OVERVIEW

Above are example photos on how to differentiate between the previous and updated 8 Zone LAN Expander module. The updated version will be the same part number/sku; IR-996005PCB&K at CSD, 21120 at AG.

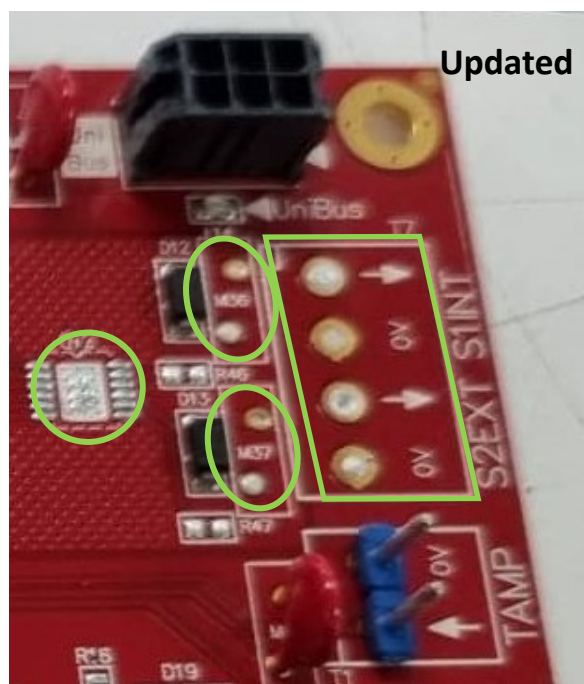
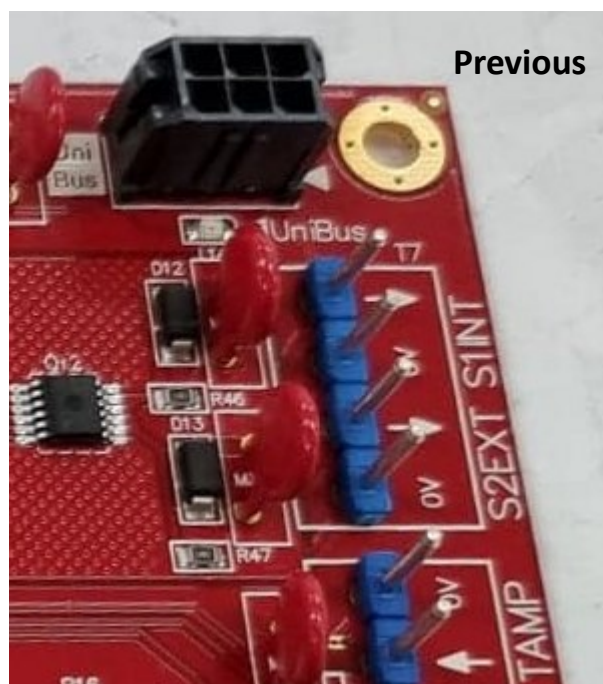
Due to global component shortages, Inner Range have been unable to supply some components and have resulted in the removal of the siren driver from their 8 Zone LAN Expander. All other inputs and outputs function as normal, as well as the 8 Zone input and 8 Relay output UNIBUS expanders when the 8 Zone LAN Expander is being used as a UNIBUS host. This now means that the 12V DC output and relay outputs on the 8 Zone LAN Expander will need to be utilised to drive a 12V DC siren if an alarm sound is required. This also means that the different siren and event tones available within Integrity and Inception (chirp, squawk, sweep and others) cannot be utilised to drive a regular 8 Ohm horn speaker.

Note that the Q12 chip, R46/R47 resistors, M56/M57 capacitors and pins have been removed.

12V DC sirens are available from CSD and we recommend to ensure there is sufficient a power source operating the 8 Zone Expander. Different 12V DC sirens may offer different sound tones with multiple input triggering, which the Relay outputs of the 8 Zone LAN Expander will be required to be utilised.

Options to monitor the siren tamper should also be disabled within Integrity and Inception if using the module with the siren driver removed.
